# STAFF REPORT ACTION REQUIRED

# 117 Peter Street and 287 Richmond Street West – Rezoning Application – Refusal Report

Date:	August 11, 2010
To:	Toronto and East York Community Council
From:	Director, Community Planning, Toronto and East York District
Wards:	Ward 20 – Trinity-Spadina
Reference Number:	09 154905 STE 20 OZ

**Attachment 3: King-Spadina East Precinct Study - Height Areas**

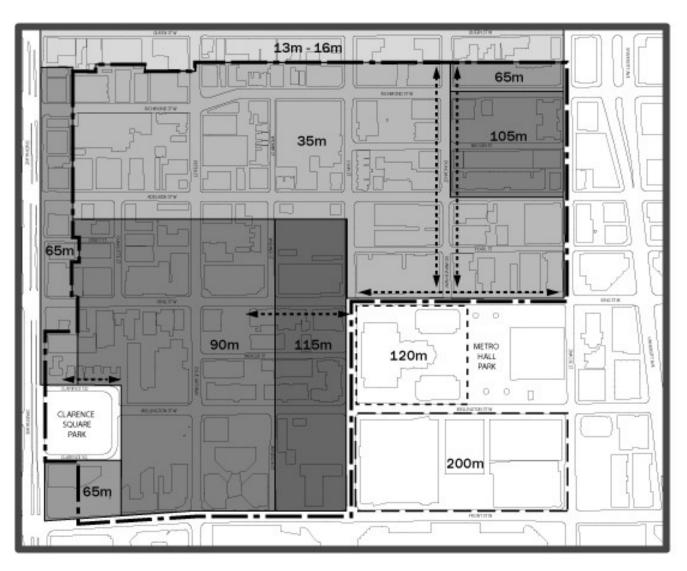
The site is in the 'Warehouse District' character area and in a 'First Tier' height zone that has a height limit of 30 metres plus 5 metres for mechanicals subject to angular plane requirements (Attachment 3). The 'Warehouse District' generally includes the Richmond Street and Adelaide Street corridors and is characterized with mid-rise brick and beam buildings, many of historic significance. The mid-rise built form character of the 'Warehouse District' is one of the most distinctive features of the King-Spadina area. The preservation and enhancement of this character is an important goal of the King-Spadina planning framework.

The proposal is also inconsistent with the directions provided by the East Precinct Built Form study. The site is in the 'First Tier' height zone which is the lower scale area of the Warehouse District where height is limited to the as-of-right permission in the zoning bylaw of 35 metres. The limit on height within this zone is intended to protect and reinforce the desired physical form of development which is the mid-rise historic built form character of the Warehouse District, while providing for new development. It also provides a transition area from the 'Second Tier' height zones to the south and east to the low-rise area in the Heritage Conservation District along Queen Street West to the north, further strengthening the historic built form character of this area of the Warehouse District.

**Attachment 4: Site Plan**

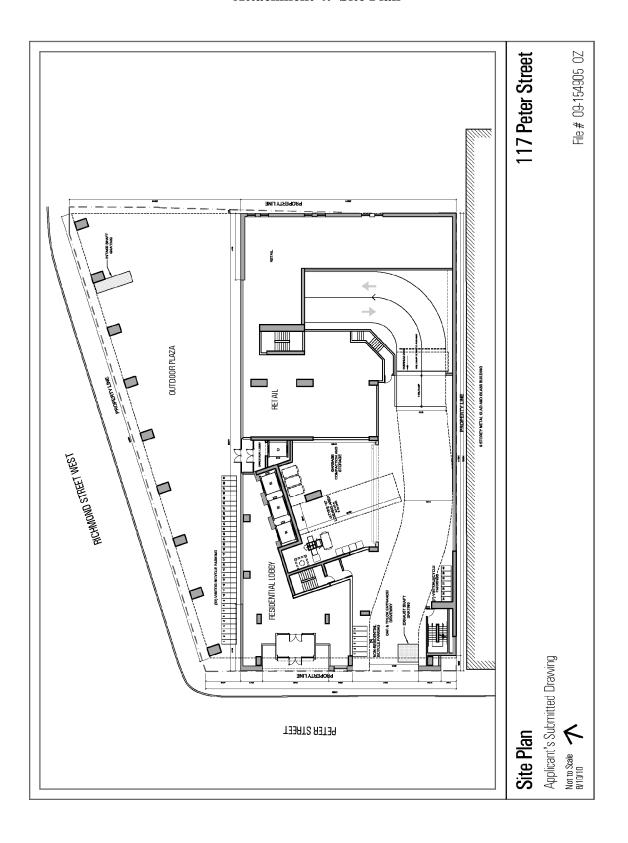
The proposal has a revised gross floor area of 29,019 m<sup>2</sup> and an overall building height of 124 metres to the top of mechanical penthouse (117.0 metres plus 7.0 metres for mechanical penthouse). Five (5) levels of underground parking are proposed to accommodate 219 vehicular parking spaces. See Attachments 4, 5 and 6.

The revised proposal creates a publicly accessible open space at grade along Richmond Street that mirrors the plaza across the street and is sheltered by a 4 storey high "tabletop" with the residential tower above. The proposal also incorporates the façade of the existing warehouse building at 117 Peter Street which contributes to the character of the streetscape. The tower floorplate has been reduced from approximately 950 square metres to 857 square metres with a corresponding increase in separation of the tower from the property lines.

- a maximum height of 5 metres is permitted for rooftop mechanicals and the mechanical penthouse is 7.0 metres high
- a minimum 3 metre stepback of the building from the street line above a height of 20 metres is required
- minimum side yard setbacks of 7.5 metres are required for the portion of the building located beyond 25 metres from the street line and the building is setback 0.4 metres from the east side lot line and 0.0 metres from the south property line
- a minimum rear yard setback of 7.5 metres is required from the rear lot line and the building extends to the rear lot line
- no window of a dwelling unit (other than a window of a kitchen or bathroom) is permitted closer than 7.5 metres to a lot line that is not a street line

## **Attachment 5: Elevations (1)**

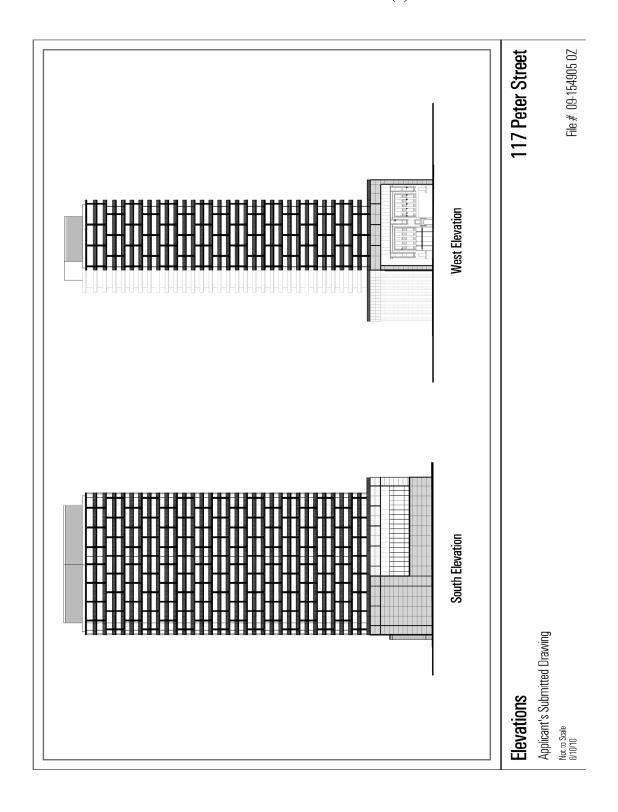
The proposed building exceeds the maximum height of 35 metres (including mechanicals) permitted in the zoning by-law by approximately 89 metres for a total height of 124 metres. Other areas of non-compliance with the Zoning By-law have been identified as follows:
